Subject: AP1000 Response to Request for Additional Information (TR03)

Response to Request for Additional Information on Technical Report 03

RAI Response Number: RAI-TR03-010
Revision: 4

Figure RAI-TR03-15-1-Strain-iterated shear wave velocity profiles

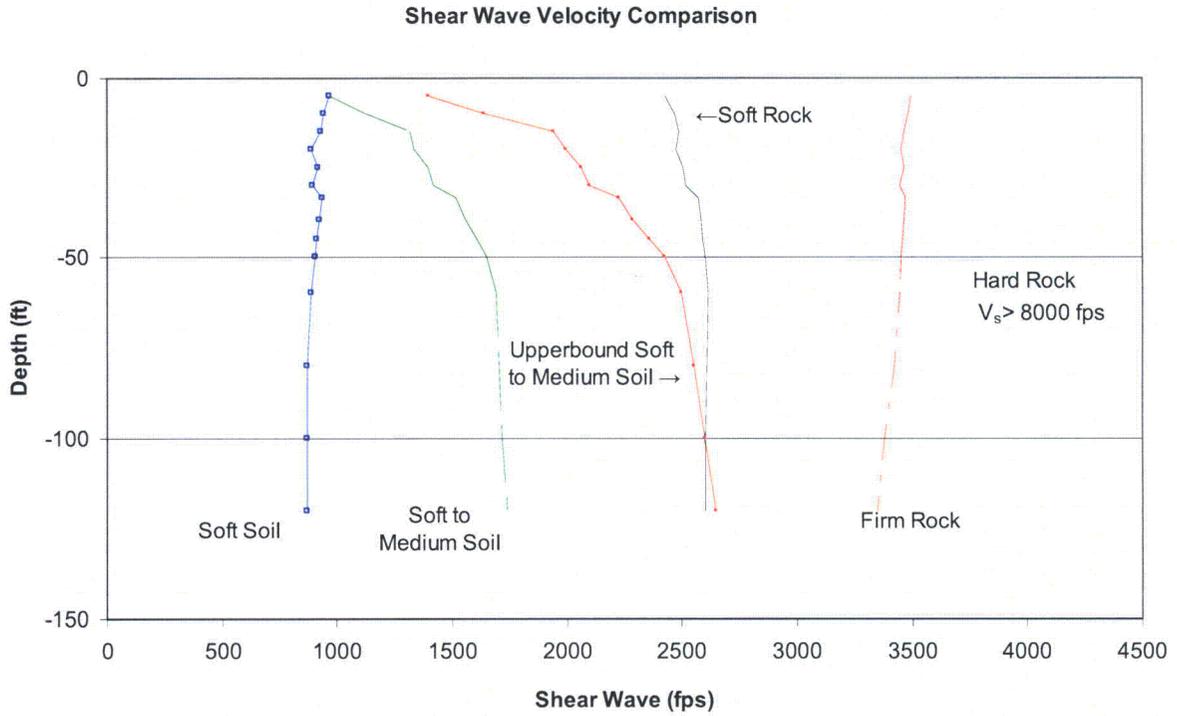
In Page 48 of 154, Westinghouse illustrated that some effects (water table, soil layering, soil degradation model, etc.) are not significant to the seismic response of the nuclear island (NI) structures. Because these results are applied for the AP1000 design, the staff requests Westinghouse provide technical basis for making these conclusions. In addition, Westinghouse needs to demonstrate the combination of these effects is also insignificant to the seismic response of the NI structures.

Westinghouse has addressed soil degradation in RAI-TR03-10. Tables of strain-iterated shear wave velocity used in the generic analyses are shown in Table 4.4.1-3 of Technical Report 03. Figure RAI-TR03-15-1 shows the bounds of these strain-iterated shear wave velocity profiles. The combination of effects of the different soil parameters is reflected in these bounds. Figure RAI-TR03-15-2 shows how a COL applicant could demonstrate that the site is enveloped by generic seismic design basis. The applicant would define its site geotechnical parameters as defined in DCD Section 2.5 and would justify why the site is within the bounds of the AP1000 generic analyses that have been considered in this technical report. These parameters would include the soil profiles used in the PSHA (probabilistic seismic hazard analysis) analyses,

which could then be compared to Figure RAI-TR03-15-1. Subsequent discussions between the COL applicant and the NRC may uncover a parameter for which more justification is required to show that the impact of this parameter on the response is small. This justification could be done with the AP1000 2D model (See RAI-TR03-010, Rev. 4 for clarification of the use of 2D analyses). An example of how a 2D parametric study would be used is shown in Figure RAI-TR03-15-3 and RAI-TR03-15-4. If the parametric 2D SASSI studies show that the effect could be significant (e.g., 90% of the design spectrum, see Figure RAI-TR03-15-4) when compared to the 2D design spectra, a 3D SASSI study would then be performed. If the 3D SASSI analyses show some exceedances at the critical locations, the applicant would then proceed to show that sufficient margin exists in the design to accommodate these exceedances.

Figure RAI-TR03-016-001: Regions Surrounding Major Penetrations

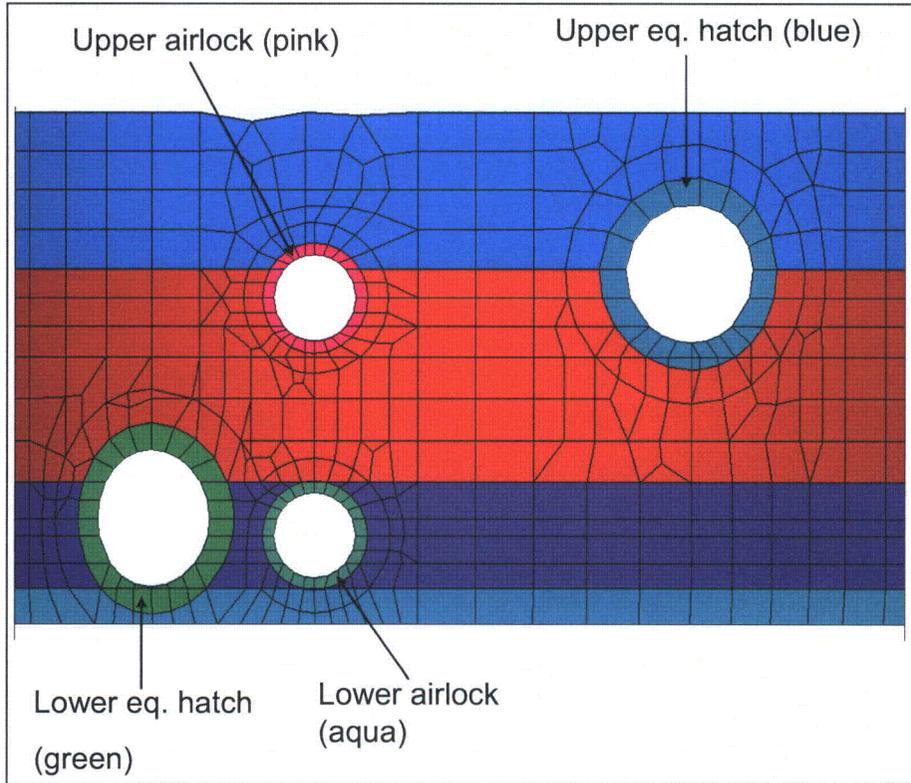
Westinghouse should demonstrate that the adequacy of using results from equivalent static acceleration analyses for the SSE response in the evaluation of the large penetrations.

Additionally, a time history analysis has been performed selecting information for the regions immediately surrounding the large penetrations as shown in Figure RAI-TR03-016-001. The purpose of this analysis is to verify that the loads from equivalent static analysis are conservative to time history using a representative study. The effects of the missing mass in the time history analysis have been incorporated by an algebraic sum of the stress intensities from a run with the left out mass accelerated at ZPA and the modal superposition time history analysis.

Figure RAI-TR03-024-1 - ASB Stick Portion of NI Combined Model

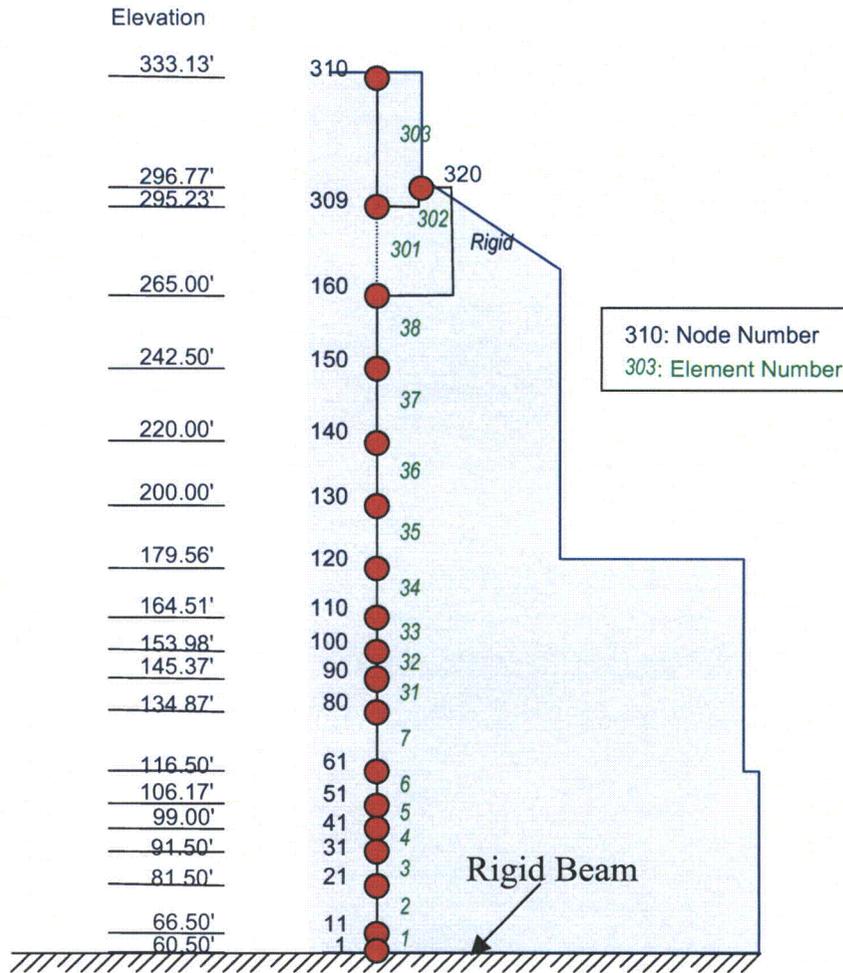
The description of Section 7.1 does not indicate whether the vertical spring/damper values were based on the rocking site stiffness value or the vertical site stiffness value and whether the horizontal/vertical parameters were determined from an assumed uniform half-space. Westinghouse should explain what are the differences in these parameters and how significant are these parameters on the computed results.

Lift off was evaluated using an East-West lumped-mass stick model of the nuclear island structures supported on a rigid basemat with nonlinear springs. This model is shown in Figure RAI-TR03-024-1. The liftoff analysis model consists of the following two elements:

1. The nuclear island (NI) combined stick model (ASB, CIS and SCV). The three sticks are concentric and the reactor coolant loop is included as mass only.
2. The rigid basemat model with horizontal and vertical rock springs

Figure 7.2-3 Modeling of Actual Footprint in East-West Model

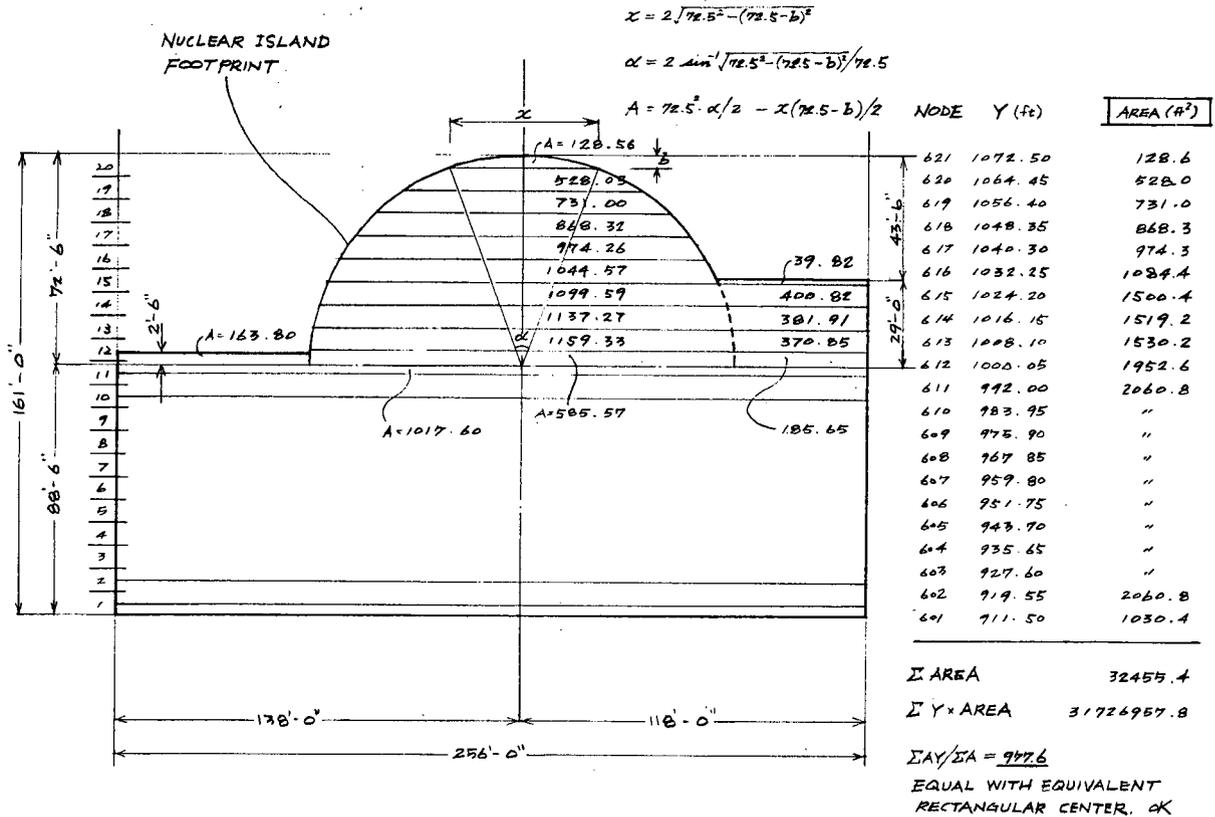
The description provided in Section 7.2 indicates that spring/dashpot values were selected based on parameters for a uniform half-space. However, for a soil site with hard rock located at a depth of 120 ft below the basemat, the resulting SSI radiation damping value would be expected to be significantly lower than that for a uniform half-space solution. Westinghouse should evaluate what is the impact of this difference on the computed seismic response?

The effect of liftoff during the safe shutdown earthquake of 0.3g and the review level earthquake of 0.5g was evaluated using the same approach described in section 7.1 for the hard rock site. The analyses used the East-West lumped-mass stick model of the nuclear island structures supported on a rigid basemat with nonlinear springs. The actual footprint of the basemat was used in the analyses of the East-West model (see Figure 7.2-3).
